**RE: Manzano High School Gym
Grading and Drainage Plan
Engineer's Stamp Date 6-8-2016 (File: K22D020)**

RE: MANZANO HIGH SCHOOL GYM – K22D020

**AMENDMENT TO
DRAINAGE MASTER PLAN
FOR
MANZANO HIGH SCHOOL**

**Manzano High School Gym project
COA Hydrology Project K22D020**

CG-100

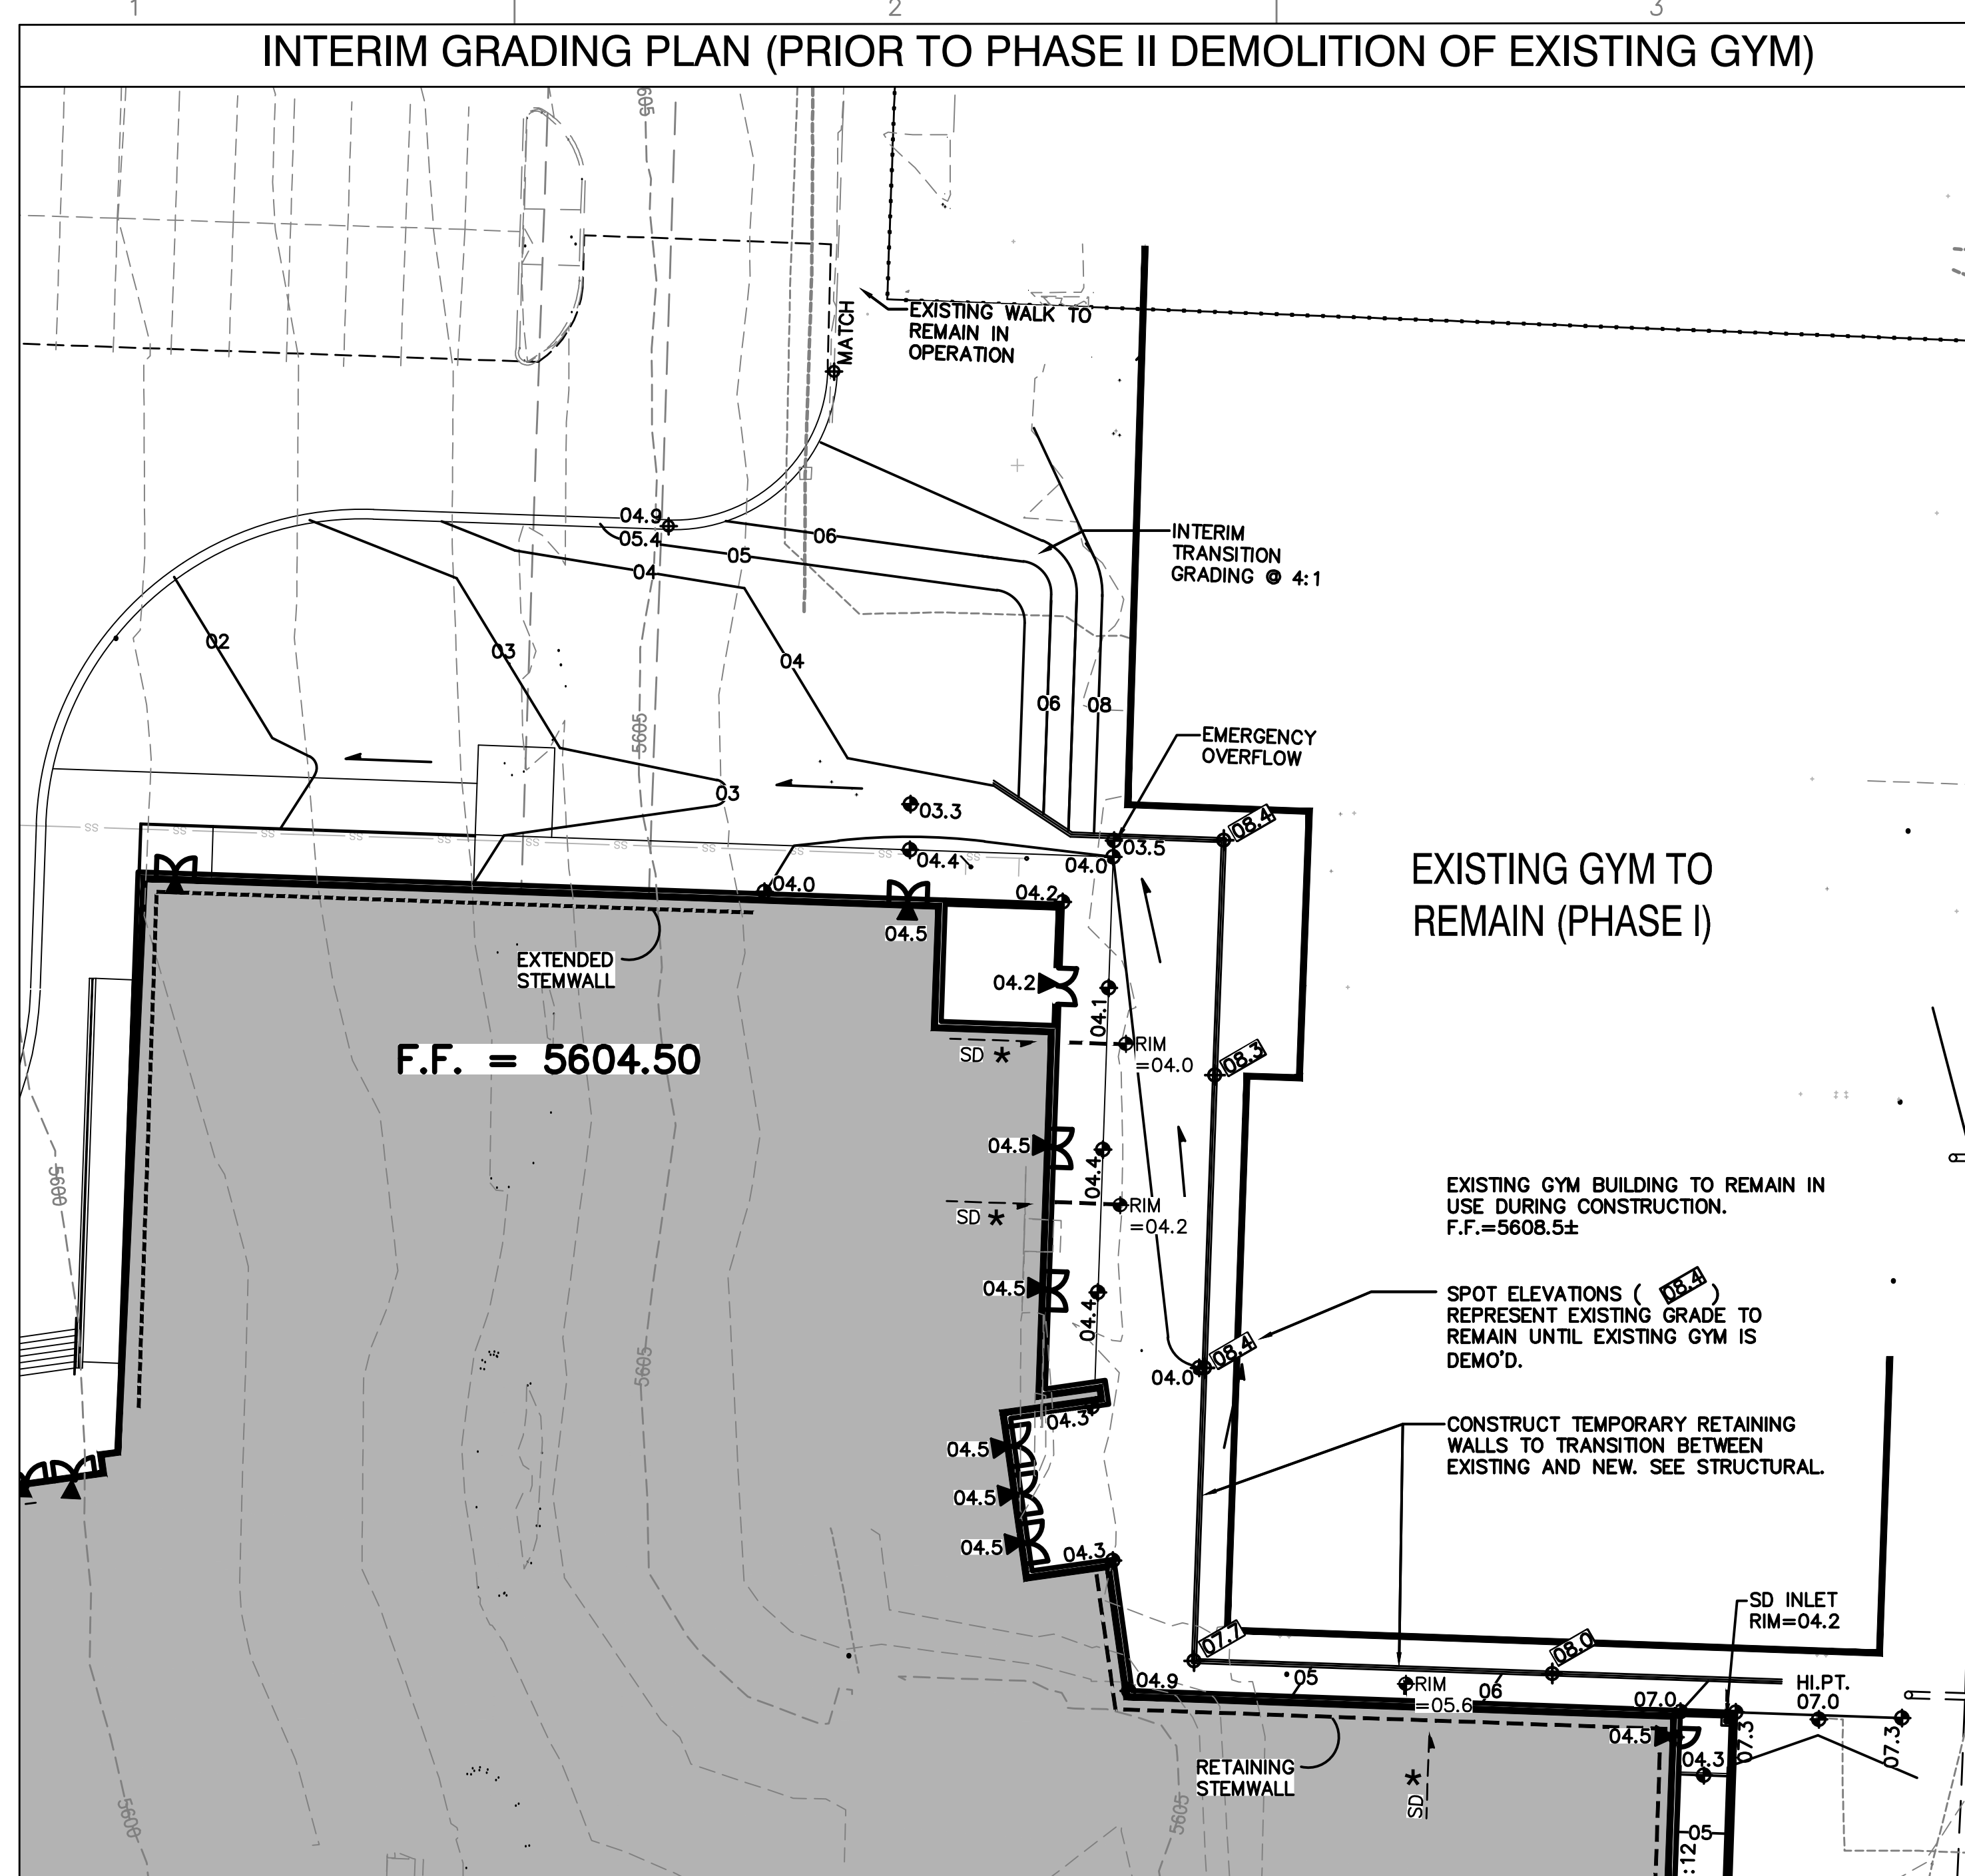
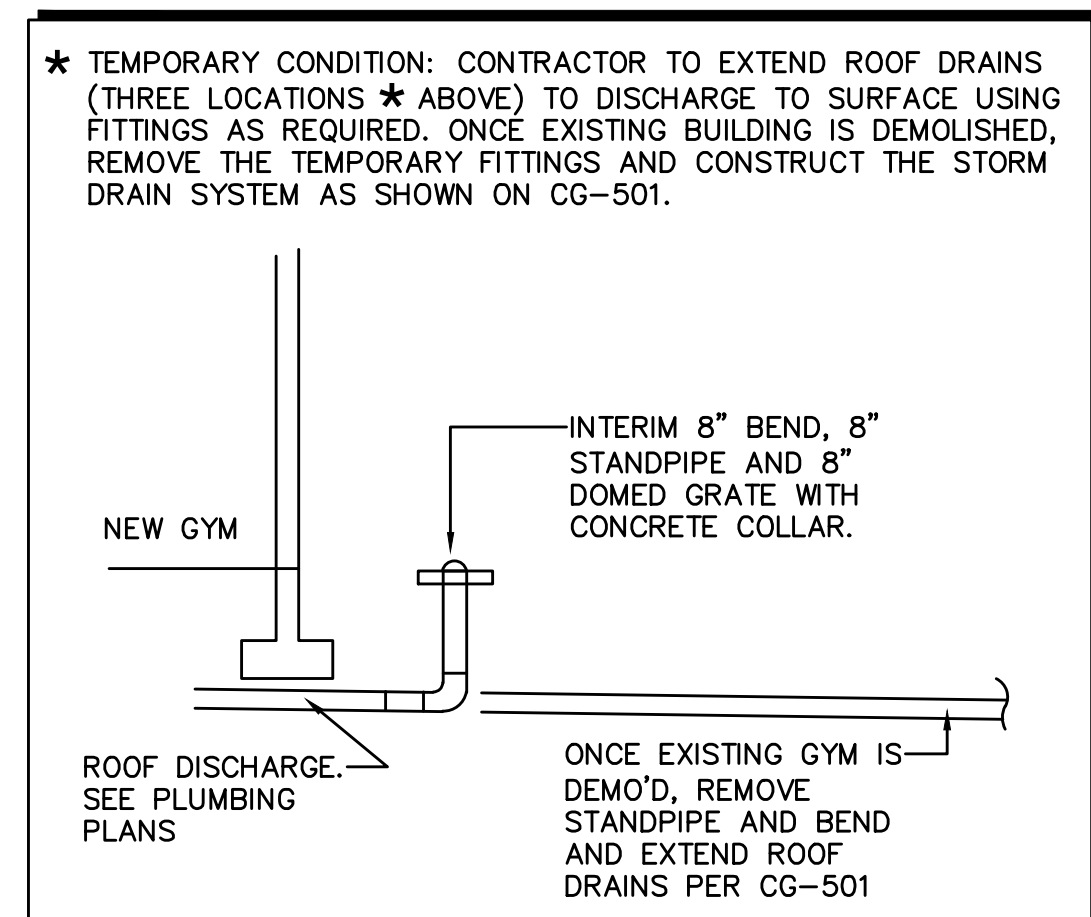
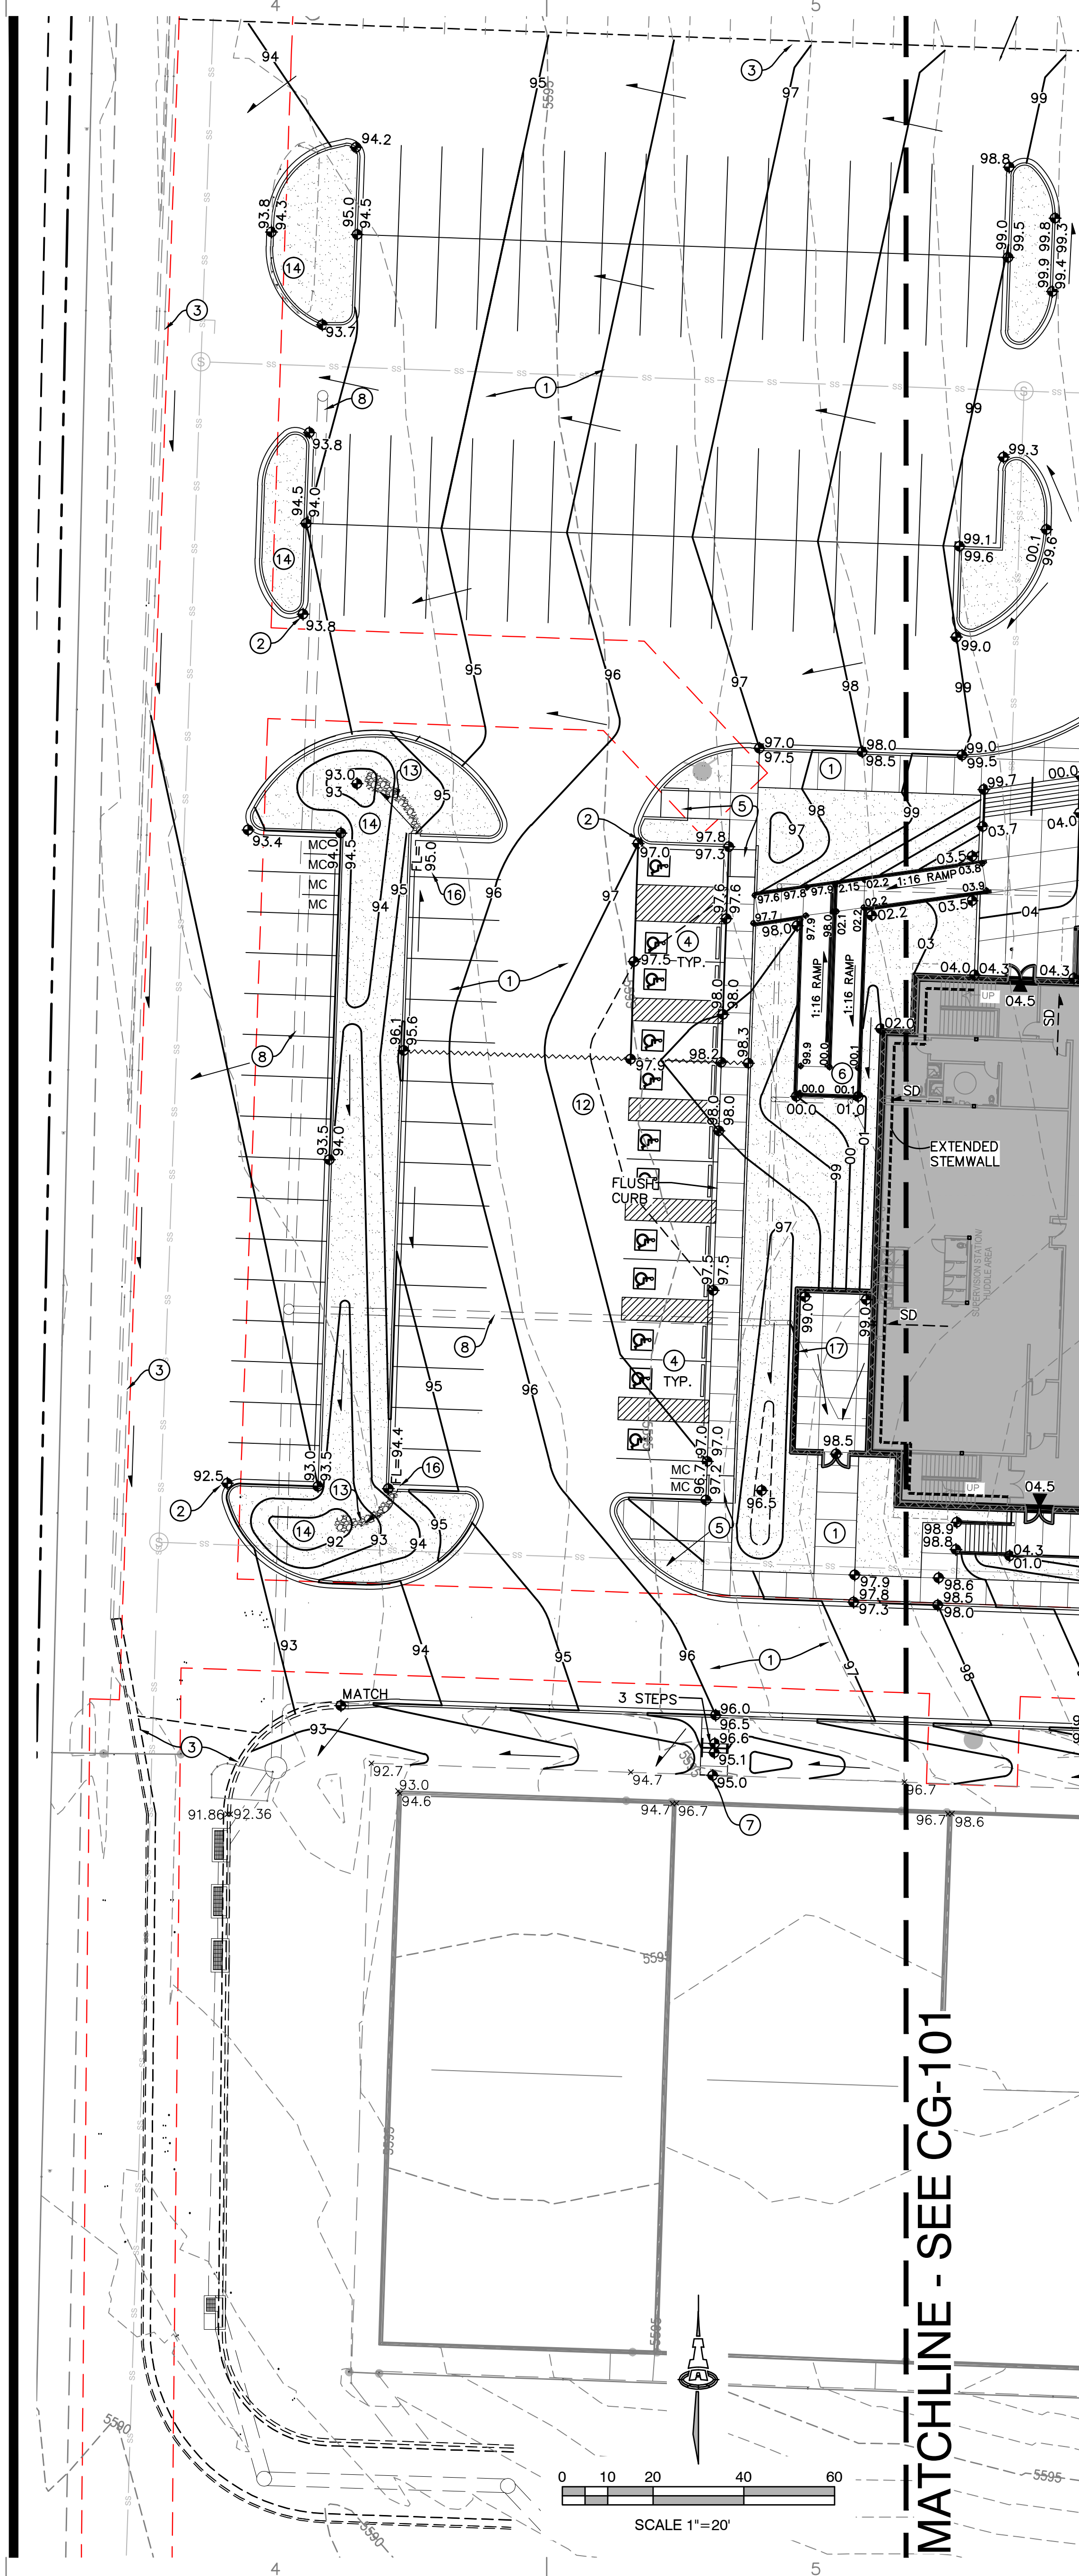
Minor revisions were made to the Project Data and First Flush notes on sheet CG-100. The following numbered responses (R) correspond to your review comments provided by e-mail on March 31, 2016 (shown italicized).

- 2. *Please ensure that the additional information that will be provided includes references (and excerpts if applicable) from the master plan for the High School.*

R: Excerpts from the approved master plan are included. Minor note changes on sheet CG-100 (labeled Rev. 1).
